**Pierce Township**  
**Zoning Commission**  
**October 3, 2023**  
**Case Number: ZC2023-007**

## **Serenite Creek Concept Plan**

**Summary:** A Concept Plan submittal for property located at 595 Davis Road. The applicant is exploring the feasibility of one (1) residential development concept.

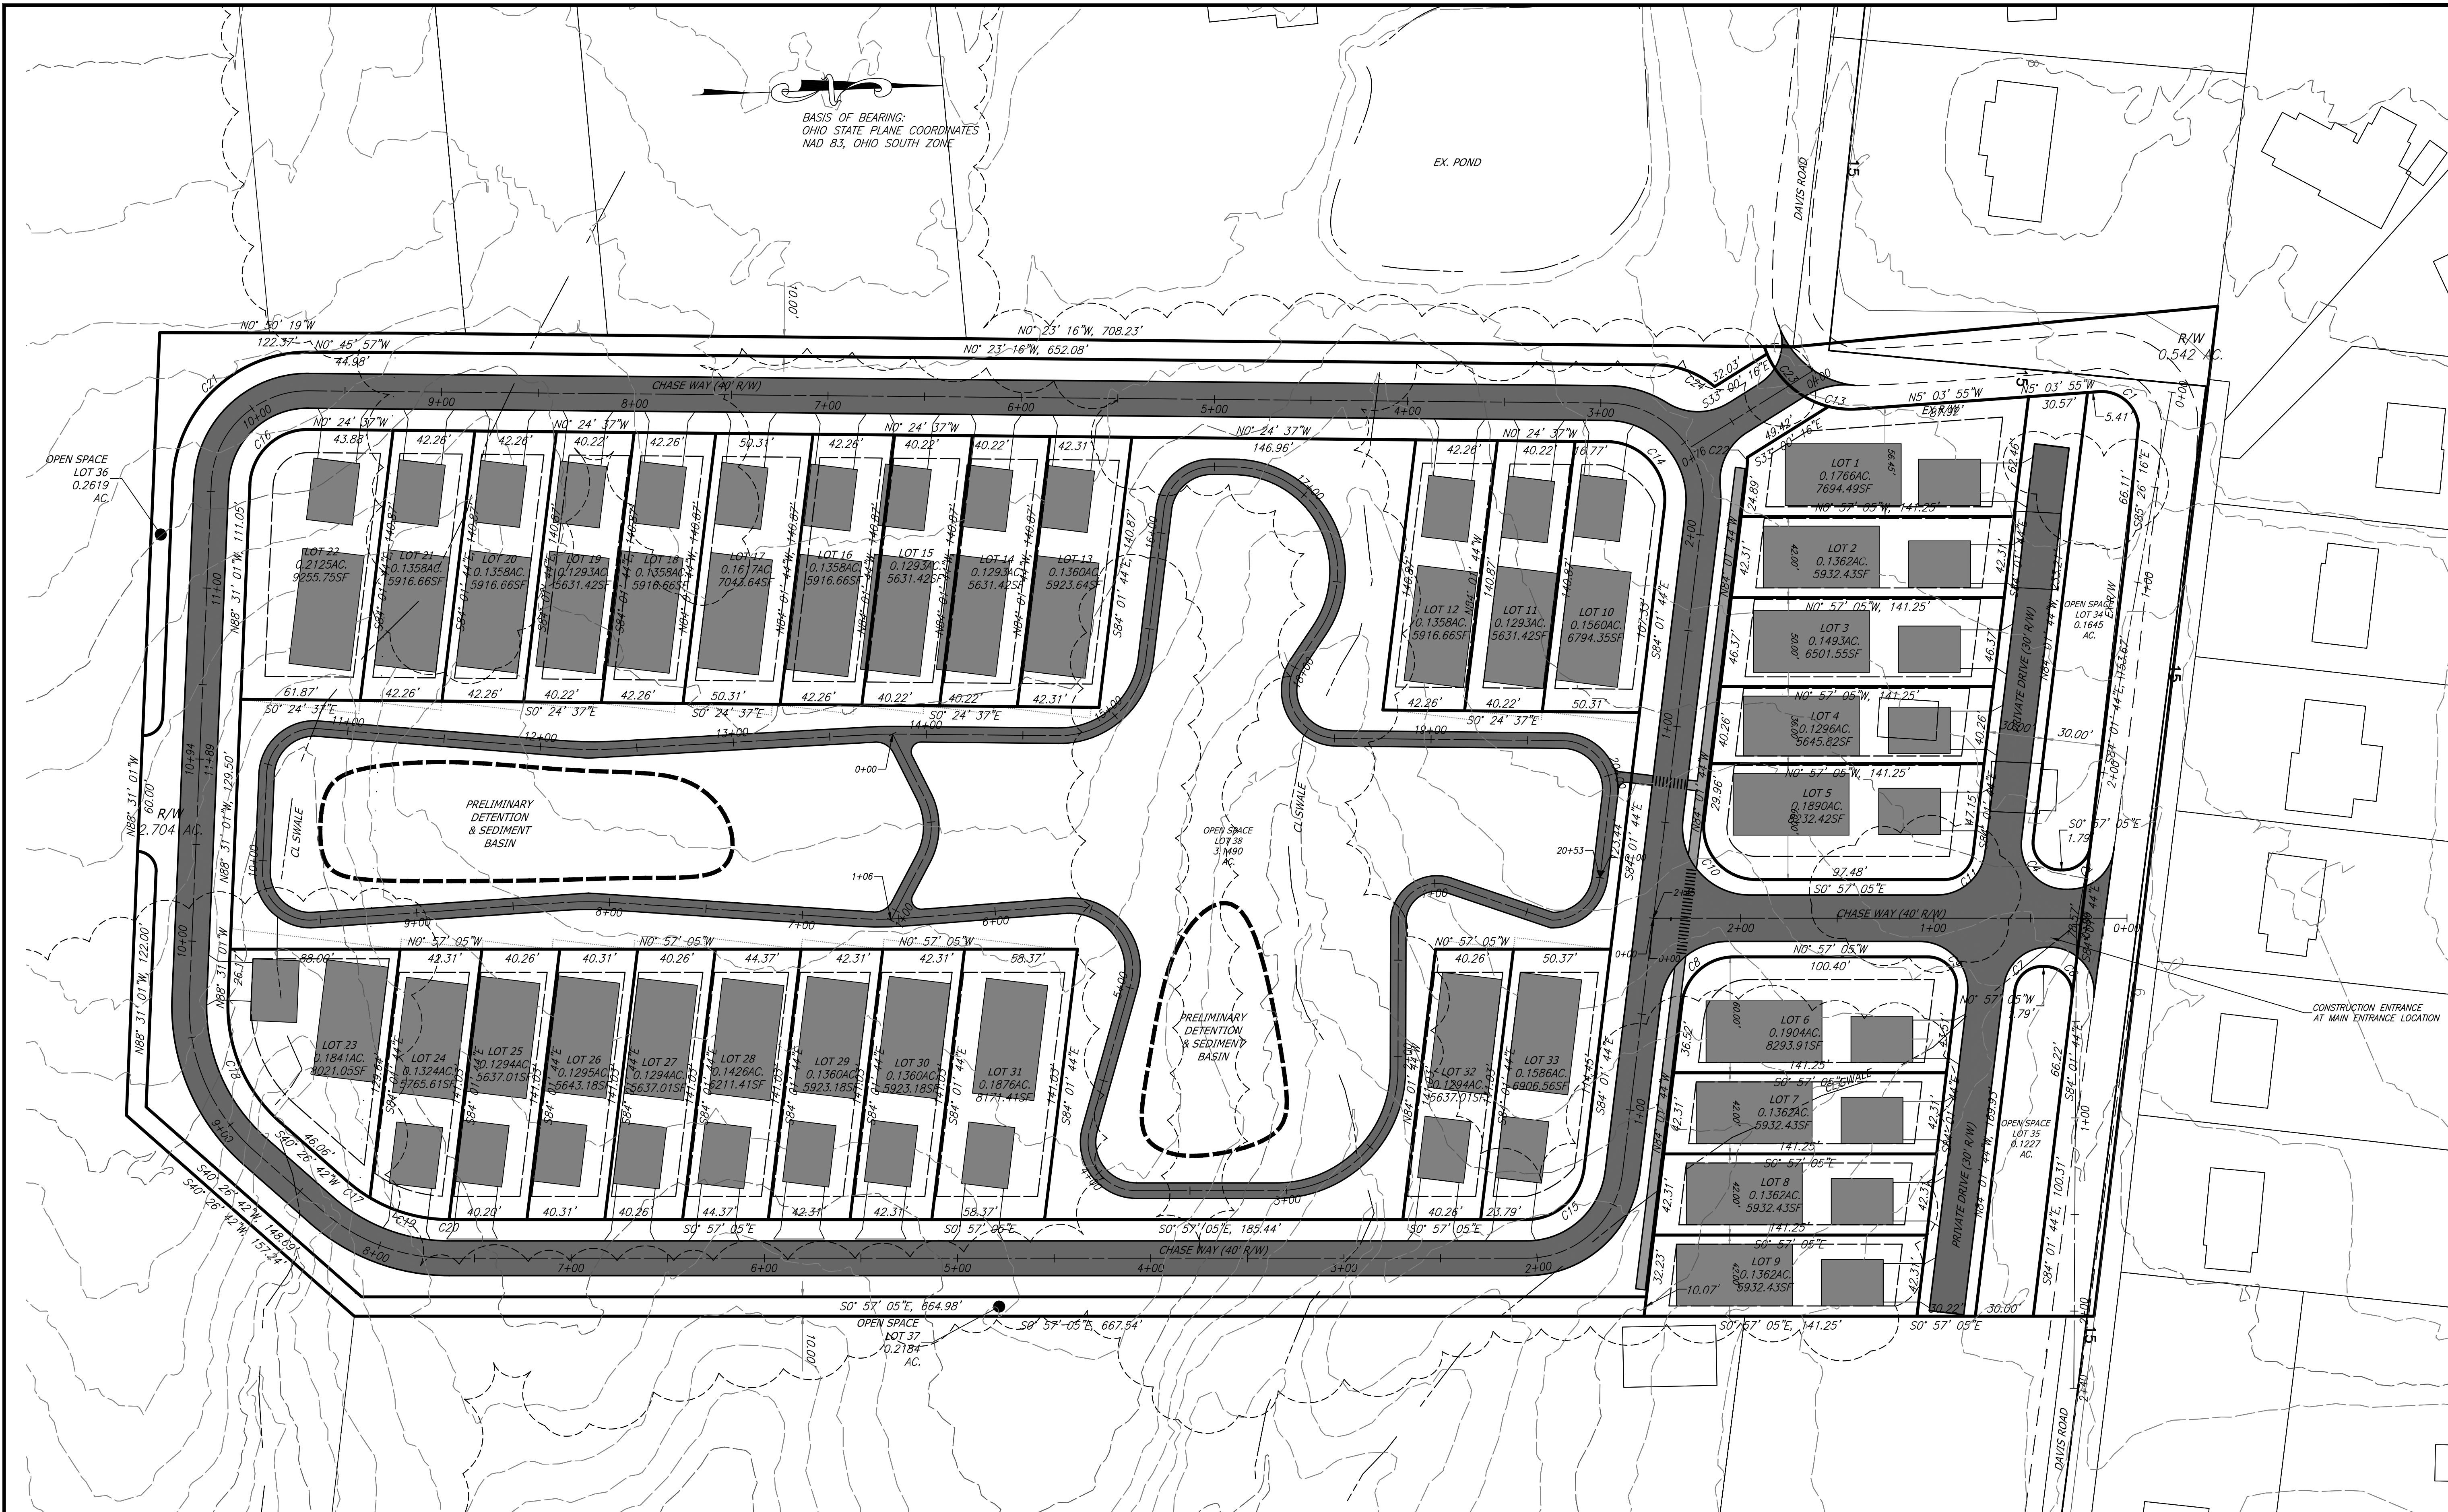
- 4) Landscaping- Please provide landscaping plans for public hearings, when available
  - a. Priority evergreen landscaping
    - i. Along Davis Road berm

- ii. North facing sides of Lots 10 and 33 (viewshed of Lots 1-9)
    - iii. South side of 32 (Trail is close)
    - iv. West facing side of Lot 1
    - v. Buffering around the Eastern and Western open space areas behind the garages is critical

- vi. Landscaping at house corners should be prioritized
    - vii. Tree protection and riparian buffering is a critical component
- 5) Architecture – When the Map Amendment application is submitted, exterior elevations and floor plans will be needed for the home types. Façade architecture provided appears to meet the Land Use Plan vision

- 7) Stormwater – Is underground detention or an agreement with the neighboring site a potential option?
  - d. The preliminary storm facility in front of Lot 19 may be defeating the purpose of the “open green”.

- e. The storm facility adjacent to Lot 31 may result in a bit of tree clearance
- 8) Open Space - A common gazebo with fire pit/community gathering space would achieve a major component of the Land Use Plan and active open space requirement

- c. A stub to the south may not be necessary, as this development is unique and self-contained.

- a. The trail should run along the fronts of the home sites and be connected by a walkway

12) Lot 9 appears to be a potentially challenging lot

- a. Some additional spacing can be achieved such as placing the primary structure on Lot 23 along the south lot line (potential zero lot line or 6' south line setback) and placing the garage to the rear (Creates additional space between 23 and 24). Lot 24 can be zeroed on the southern lot line once the shift occurs, thus creating some additional side yard space between 24 and 25
  - i. You have a done a good job with this on Lots 30 and 31
- b. The same approach can be taken on Lots 13/14 and 22/21
